Subject: Design Plan - Redesign of Berm Additional Information
Nursery Products Hawes Composting Facility

Subject: 1,000-year Berm Redesign to Account for Compost in 'Overflow' Area
Nursery Products Hawes Composting Facility

Subject: Design Plan - Redesign of Berm
Nursery Products Hawes Composting Facility

PROJECT: WASTE COMPOSTING FACILITY
 LOCATION: SAN RAMON COUNTY, CA
 DRAWING NO.: 2
 OF
 8
 DATE: 11-13-08

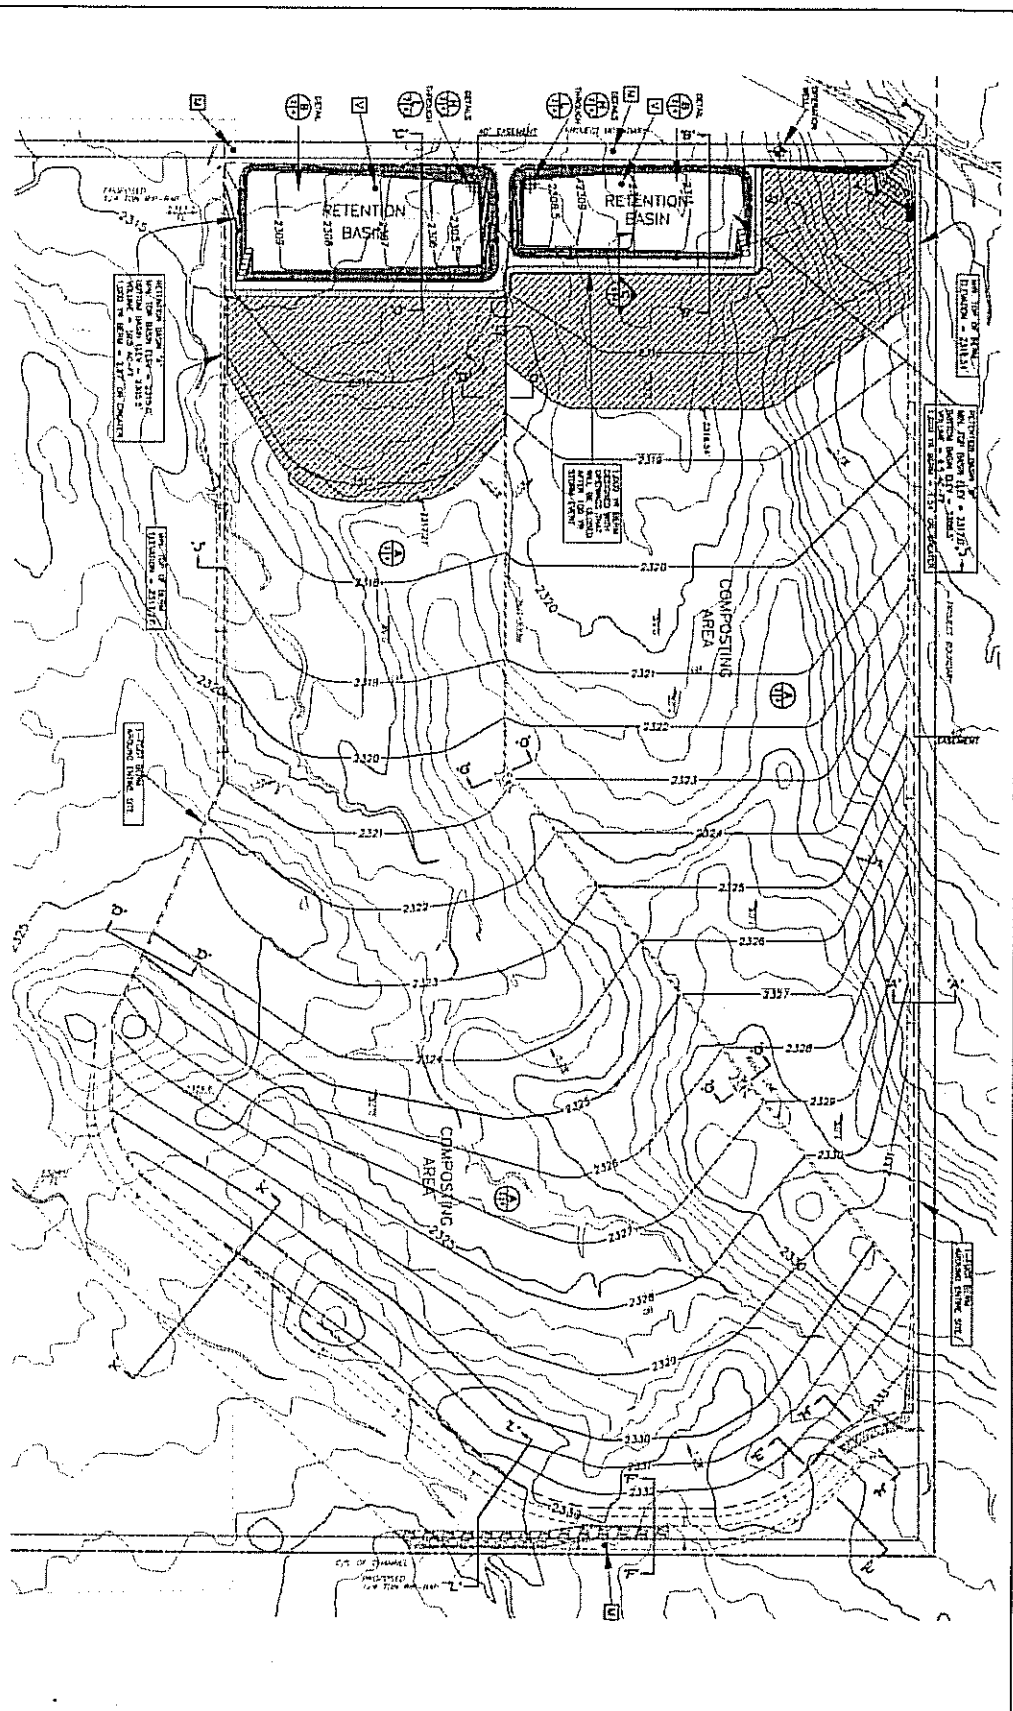
As a result of the redesign, the volume of the 'overflow' areas will be expanded to include any compost that could be located in the overflow area on those occasions when the facility is operating at full capacity. The 'overflow' area will only contain compost when the Facility is operating at full capacity and then it can only contain a maximum of 17,000 cubic yards of compost windrows. These windrows would displace 2,843 cubic yards within the depth considered in the 'overflow' area. This volume is based upon the typical size and dimension of windows as described in our

submittal of October 14, 2010. The Nursery Products Design Plan submitted August 11, 2010 established a minimum elevation height of 2317.14 feet for the berm around the overflow area "A" (7 acres) which is located on the west side of the Facility and established a minimum elevation height of 2318.41 feet for overflow area "B" (6.7 acres) which was on the east side of the Facility. It's important to remember that notwithstanding the added berm height surrounding the 'overflow' area, the entire site will be surrounded with a one foot berm. In addition, and as shown on the maps provided including the attachment hereto, the site will be graded with the lower areas in the north (where the 'overflow' area is located). Please carefully consider the elevation relationship between the one foot berm and the raised berm that surrounds the 'overflow' area. The Water Board questions about the berm height seem to indicate a misunderstanding of the site grade, one foot berm and elevated berm for the 'overflow' area. Clearly, at a location very close to the southern end of the 'overflow' area, the one foot berm will surpass the added berm needed to contain the 1000 year, 24 hour flood. It is our belief that in its review the Water Board has consistently overlooked that transition point because the 'overflow' area as proposed by Nursery Products in the Design Plan Addendum already surpassed the added volume that may arise when any compost comes to be located in the 'overflow' area. Nonetheless, Nursery Products will raise the berm elevation by 1.55 inches for area "A" and 1.55 inches for area "B" which will change the minimum berm elevations to 2317.27 feet and 2318.54 feet respectively. The higher berm heights will add an additional volume of 2,854.9 cubic yards (13.7 acres X 1.55 inches) to the 'overflow' area behind the berms.

This letter certifies that AEI-CASC has reviewed and approved the redesign of the 1,000-year berm to account for compost that potentially could be in the 'overflow' area. My seal as a registered professional engineer licensed in the State of California is affixed below.
